Clutch Pedal Squeak/Creak Noise

Service Category Drivetrain

Section Clutch

SUPERSESSON NOTICE

Figure 1.

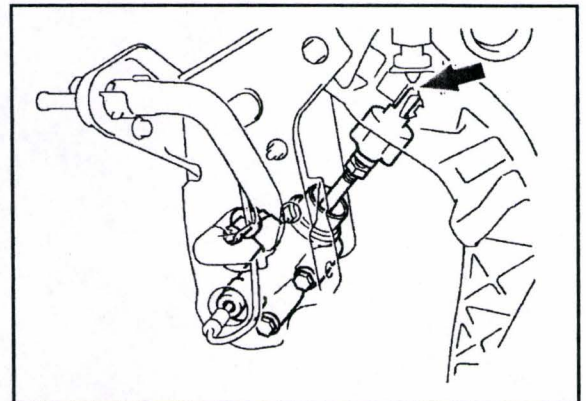
Be sure to apply MP Grease where the clutch master cylinder clevis and clutch pedal meet in addition to the locations identified in the Repair Manual (See Figure 1.)
